## CERTIFICATE OF APPROVAL No 5/6A/100

#### VARIATION No 3

Gilbarco Driveway Flowmeters

## CERTIFICATE OF APPROVAL No 5/6A/100

Veeder-Root Computer VR 1648 -- Blend-control and Counter Sections with Changes for Metric System of Measurement

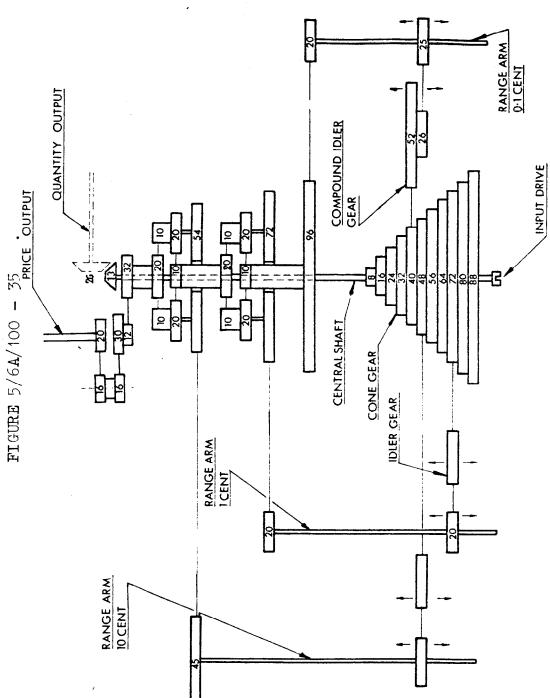
- 1. The conversion of the Veeder-Root 1648 computer (see Figure 27) from the imperial to the metric system of measurement. The modifications comprise:
  - (a) the overgearing of the drive from the meter to the computer changed to provide an input to the computer of 4 revolutions per litre;
  - (b) the gear ratio (2:1) between the price spur gear in the variator and the input gear of the counter section of the computer changed to 4:1 by the replacement of two drive gears and the addition of two compound gears (see Figures 34 and 35);
  - (c) the right-hand quantity-indicating wheel replaced by a quantity wheel with 10 graduations numbered 0 to 9;

- (d) the second-from-the-right quantity-indicating wheel replaced with a wheel marked 0 to 9; and
- (e) the dial face marked "litres" and "cents per litre".

A decimal marker is provided between the tenths and whole litre indicating wheels.

The computer\* indicates in 0,1-litre increments, giving a maximum indication of 999,9 litres, \$99,99 total price.

Veeder-Root 99,9-cent Variator with Changes for Metric System of Measurement

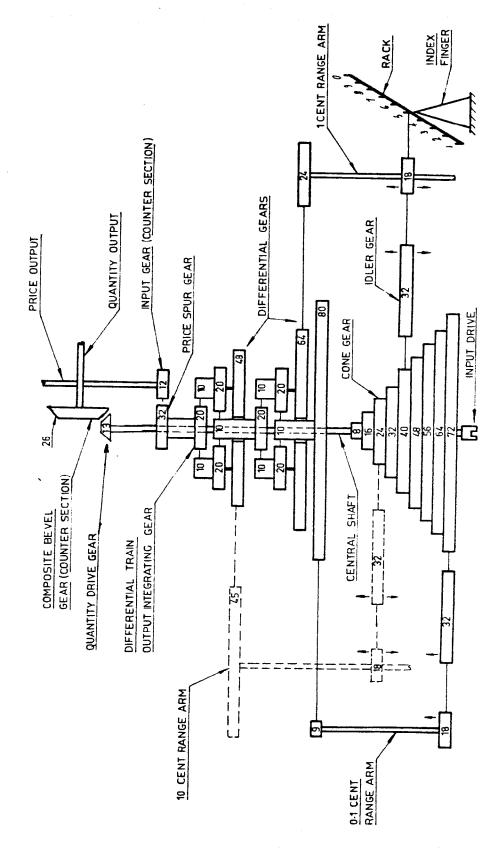
- 2. A Veeder-Root 1649 computer replacing the Veeder-Root 1648 described above except for differences in the variators (see Figure 36).
- A Veeder-Root 7525 computer replacing the Veeder-Root 1648 computer. The computer is similar to the 1648 above except for differences in the variators, and a metal guard attached to studs in the counter section preventing the price-posting wheels from being disengaged from the segmented price-posting gear (see Figures 28 and 31). The VR 101 variators are as illustrated in Figures 28, 29 and 30 except the price spur gear in the variator and the input gear of the counter section are of ratio 32: 12 (see Figure 37).

Veeder-Root M36 Computer with 4-wheel Counter-Section 5/5/78

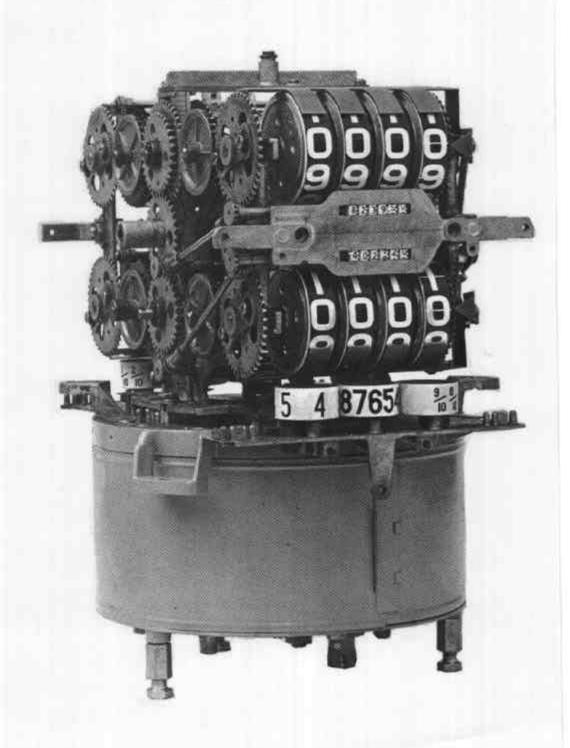
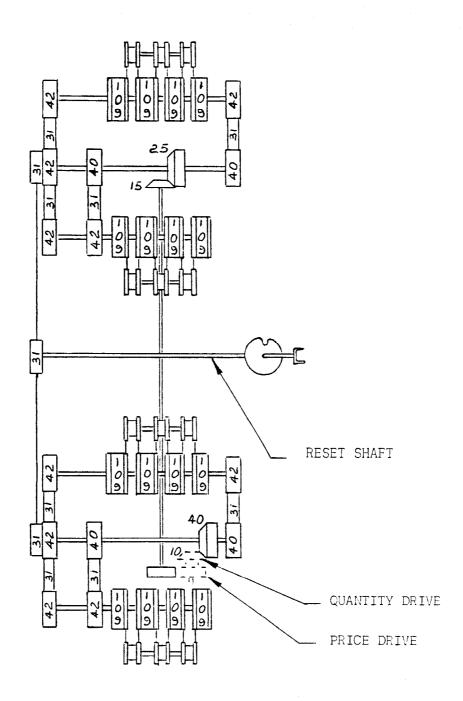
- a notice adjacent to the quantity and price indicators on each reading face of the instrument advising the user of the price limitations of the 3-wheel counter-section computers; and
- 2. a 4-wheel counter-section on the Veeder-Root computer (see Figures 38, 39 and 40).
